# SUNSHINE COAST REGIONAL DISTRICT

AMENDMENT NO.#2

Request for Proposal No. 2537011

Water System Modeling and Support Services

Figure 1 Development project overview

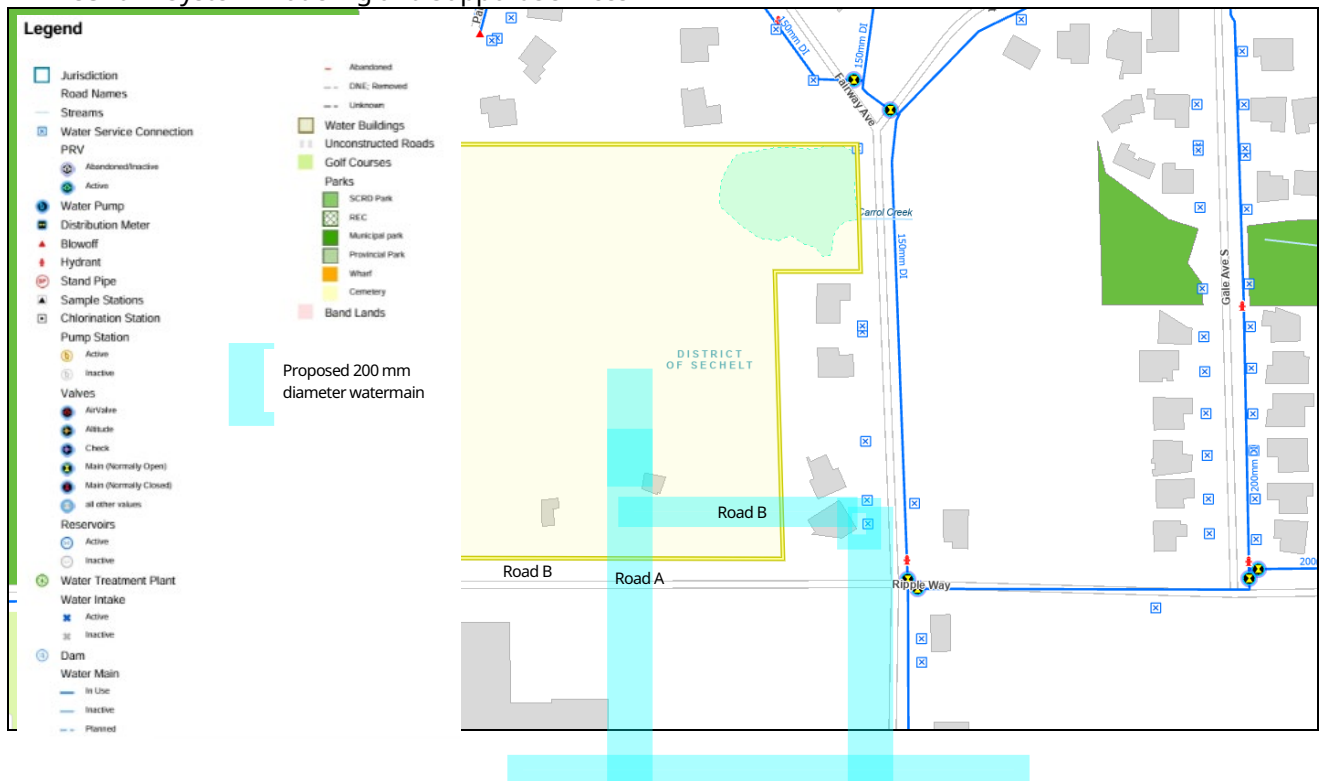
The Regional District has received an application for a 28-lot single-family residential subdivision. These lots are to be serviced by Regional District water; however, the property currently lacks an existing water connection, and there is no watermain running along the frontage of Ripple Way.

An existing 200 mm diameter watermain runs through Lighthouse Avenue and continues west along Ripple Way, where a 200 mm diameter stub is located at the intersection (Figure 1). Additionally, a 150 mm diameter watermain runs along Fairway Avenue. At the intersection of Fairway Avenue and Ripple Way, a 200 mm diameter watermain branch (Ts) off the 150 mm main and extend eastward.

The developer proposes to connect the existing watermains on Lighthouse Avenue and Fairway Avenue by installing new 200 mm diameter watermain along Ripple Way (Figure 1). This new main will tie into the existing 200 mm stub at the Lighthouse Avenue and Ripple Way intersection and will serve the subdivision.

The proposed 200 mm diameter watermain will loop through Road A and Road B, providing service throughout the development.

Fire hydrants are proposed at the intersection of Road A and Road B, and at the bend of Road B.

According to the Regional District GIS system, the existing fire hydrants have the following pressure ratings:

- 160 psi at the intersection of Lighthouse Avenue and Ripple Way
- 115 psi on Fairway Avenue, north of the site
- 85 psi at the intersection of Gale Avenue and Ripple Way

These pressure ratings will need to be confirmed.
